Appeal Period Expires 11/8/16
 Zoning District R2
Town of Essex, Vermont
Application for Zoning Permit
 www.essex.org
 Application Date 1/1/17
 Permit Number 2016-174

Re: Water/ Sanitary Sewer Applications
17 Stonebrook Circle

TOWN OF ESSEX, VERMONT APPLICATION FOR CURB CUT / UTILITY PERMIT

ETTORI
NATURE'S WAY # H-39

Lot H-39

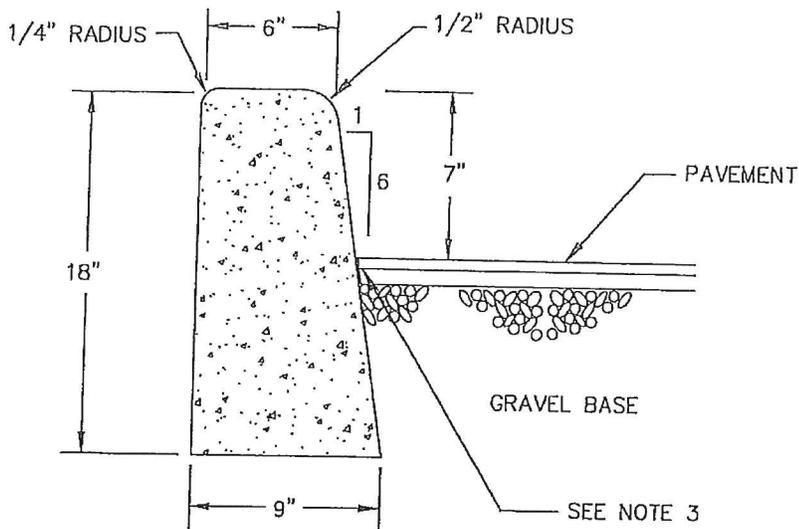
1. All work within the roadway shall be completed prior to Friday, November 18, 2016
2. The existing curb cut shall be removed and replaced with vertical concrete curb installed as shown on the attached detail.
3. The new driveway curb cut shall be a maximum of 15' wide and installed in accordance with the attached detail.
4. The pavement shall be saw cut a maximum of 18" from the face of curb. Concrete curb forms shall be used to install all new curbing.
5. All new concrete curb and pavement replacement shall be installed in accordance with the Town of Essex Standard Specifications for Construction. (See attached standard details)

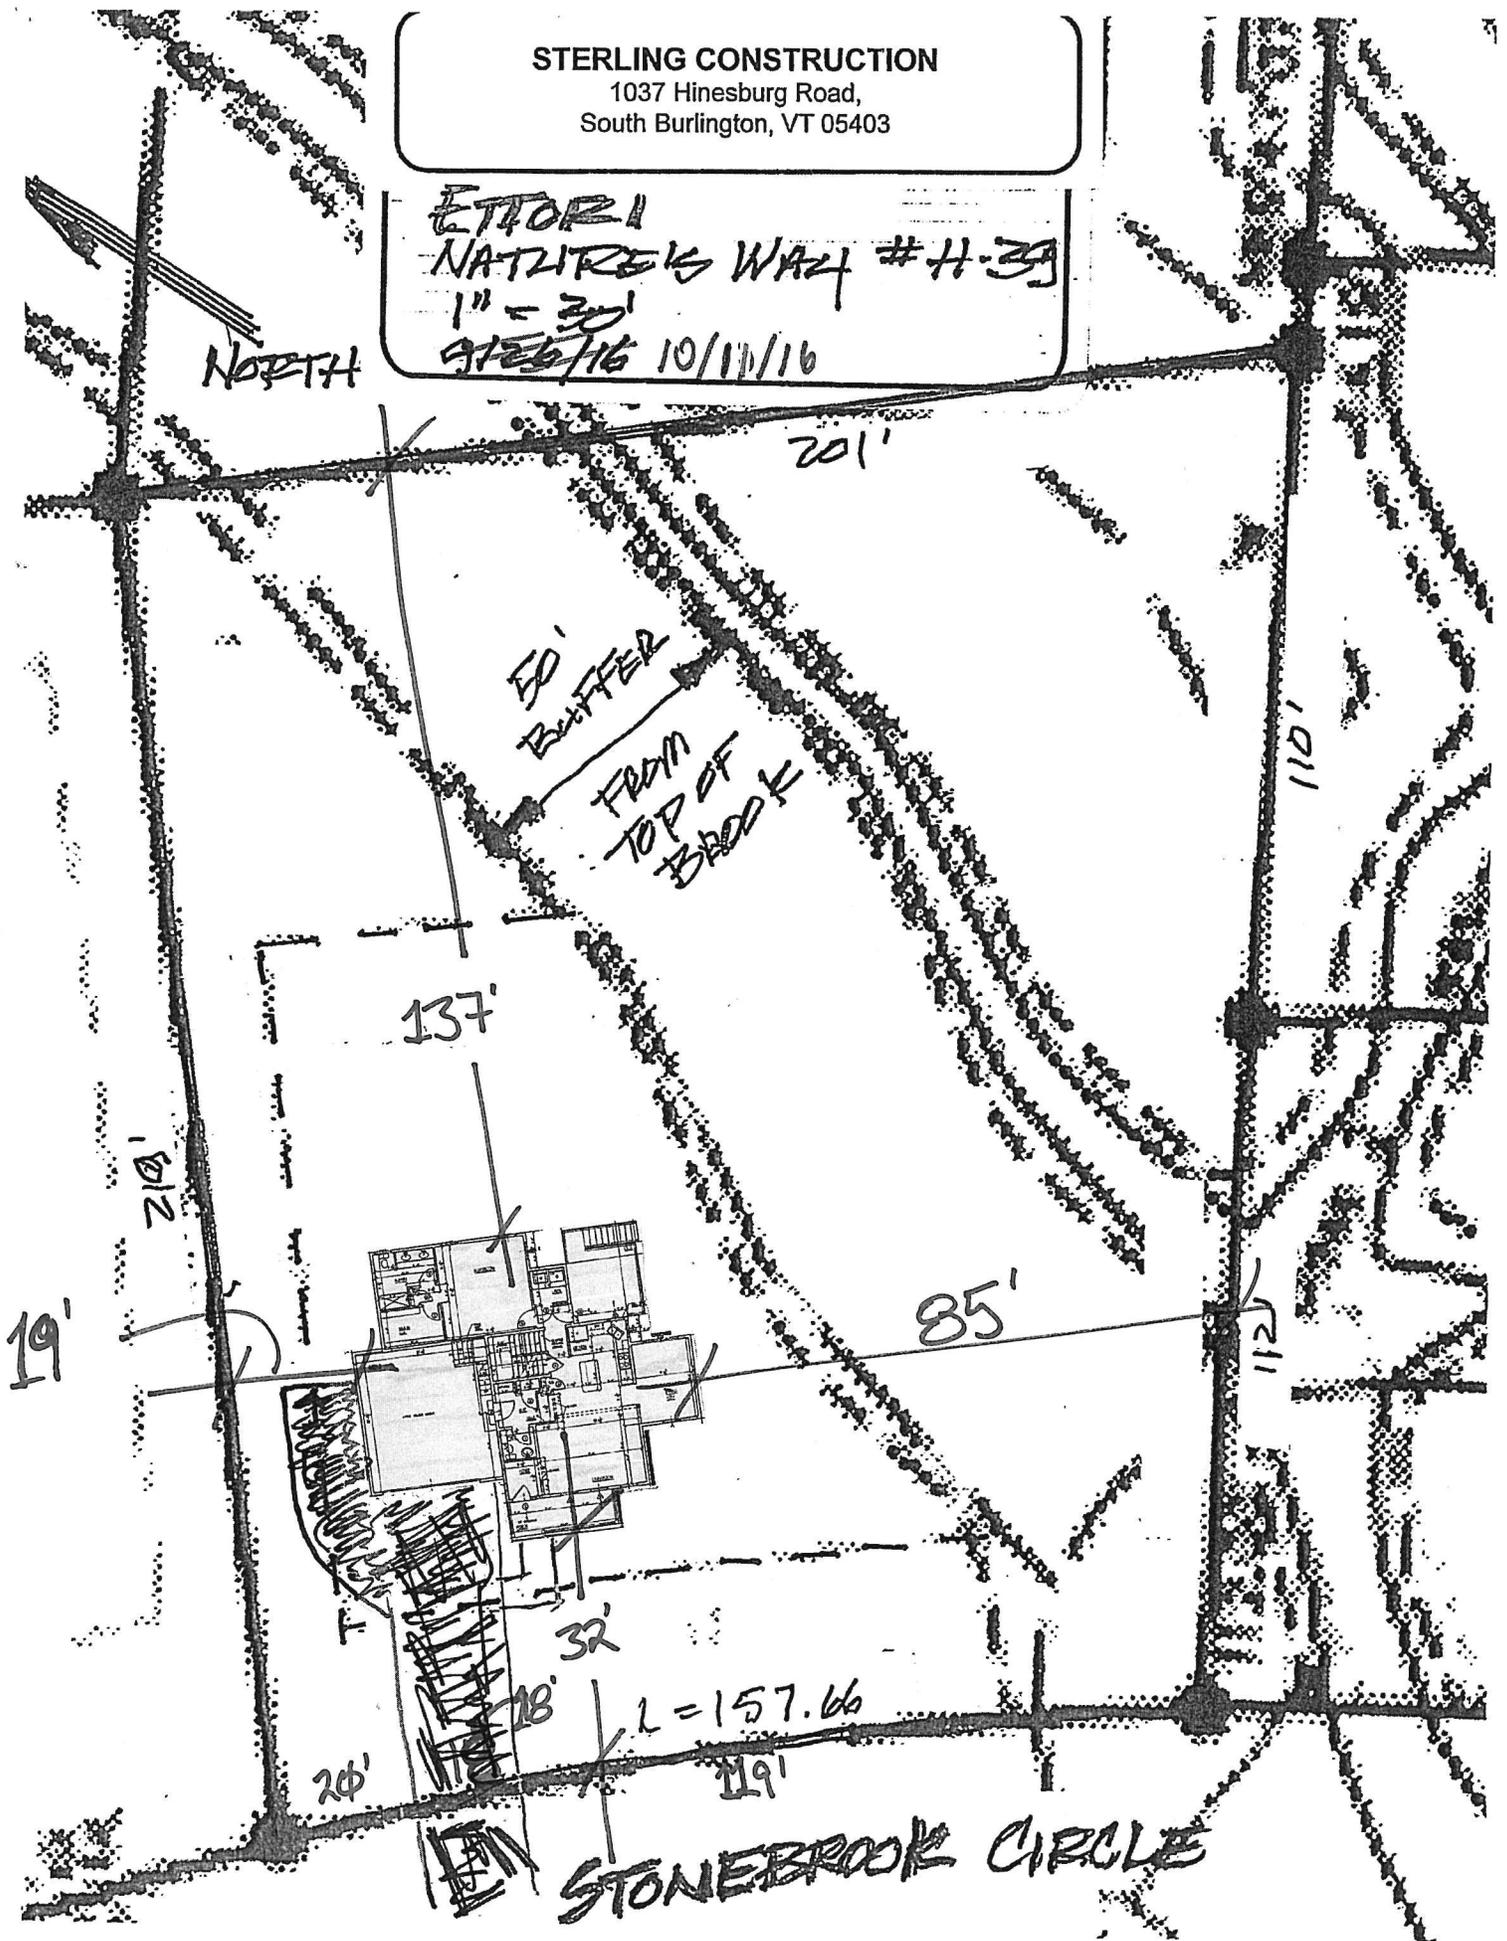
Public Works will allow the curb cut location for Lot H39 to be relocated. Please submit the application through Community Development and we will review and approve. Please note, Public Works will impose conditions on this curb cut application requiring all work to conform to Public Works standards. Inspections by Staff will be required during and after construction has taken place as well.

VARIANCE APPROVAL
CHANGES BUILDING
ENVELOPE ON LOTS 2, 3, 8
& 39 - FEBRUARY 2016 -
BWC/PJO

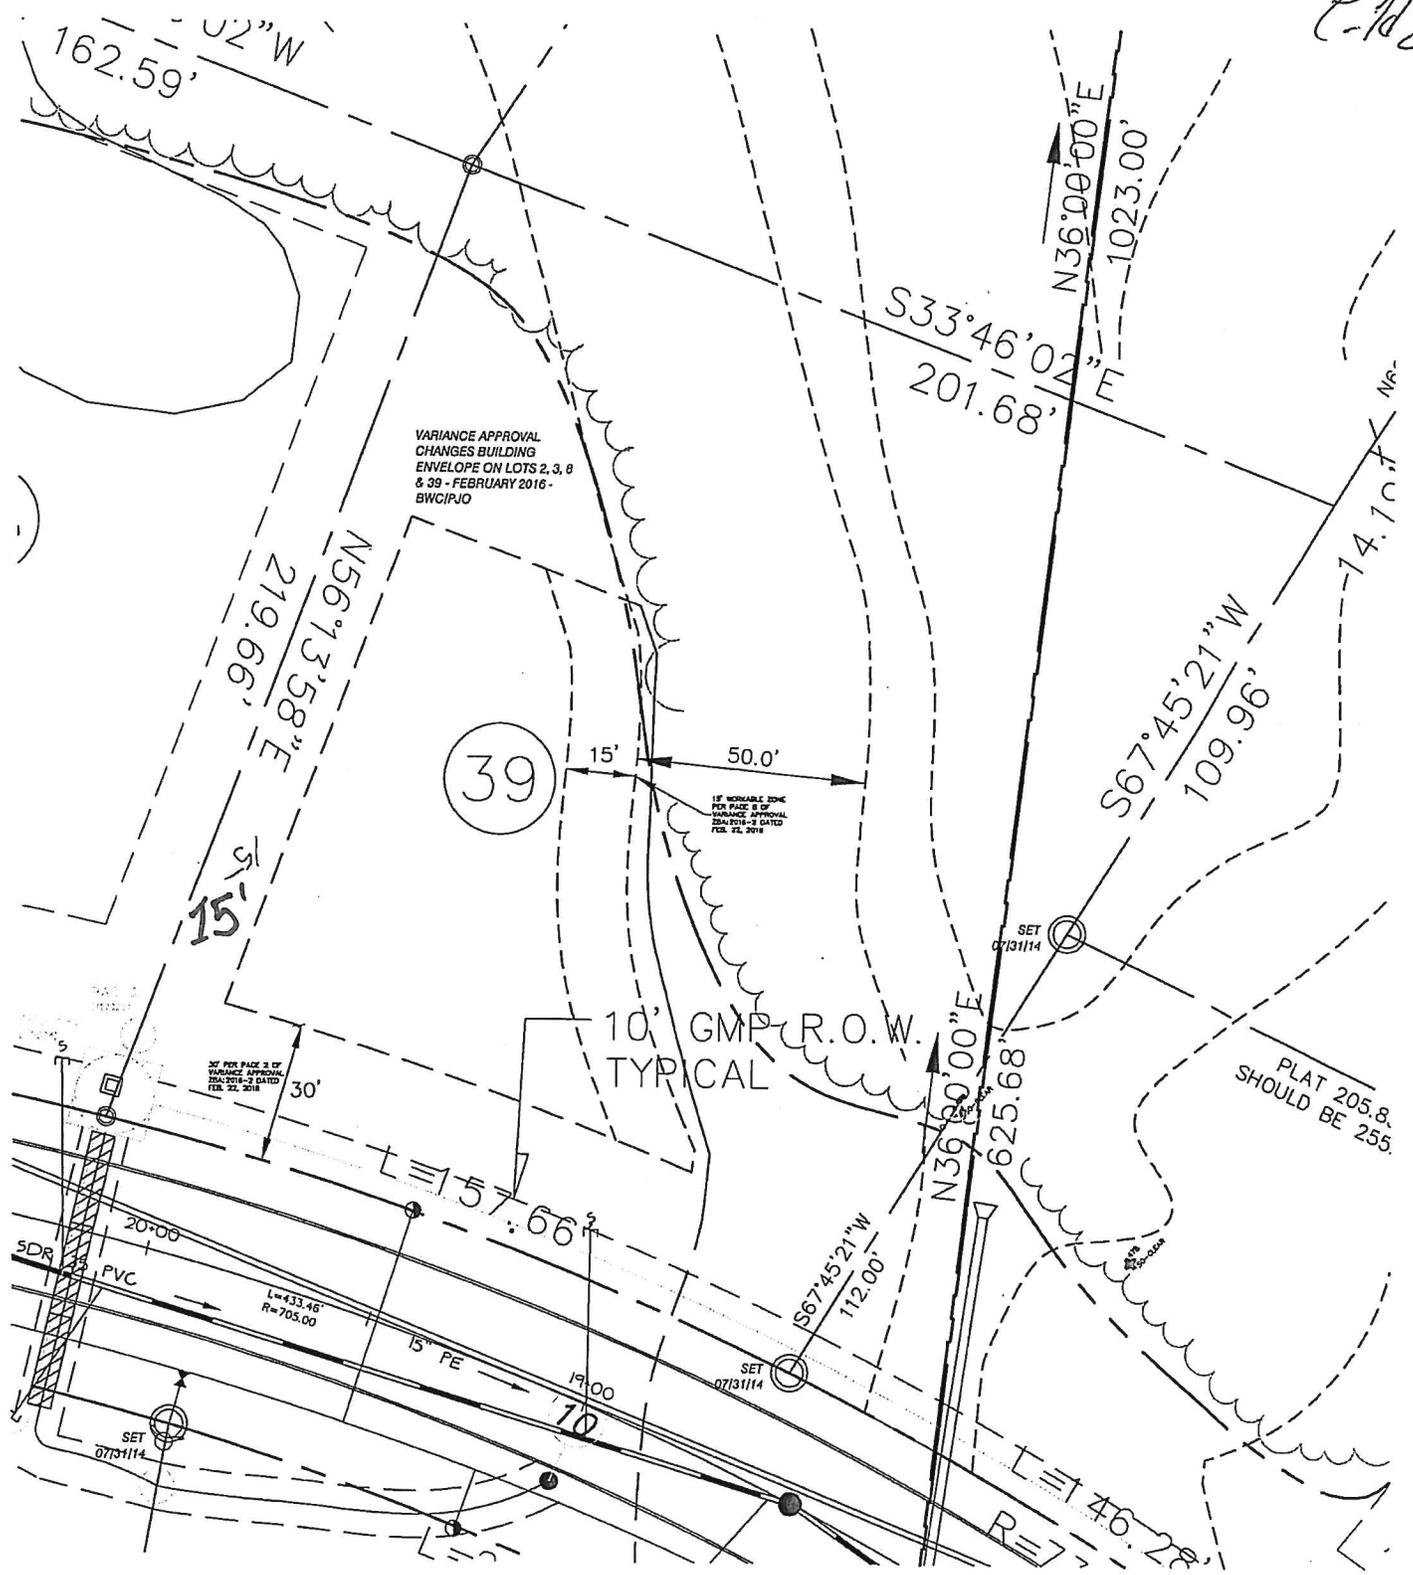
PLAT 205.8
SHOULD BE 255.
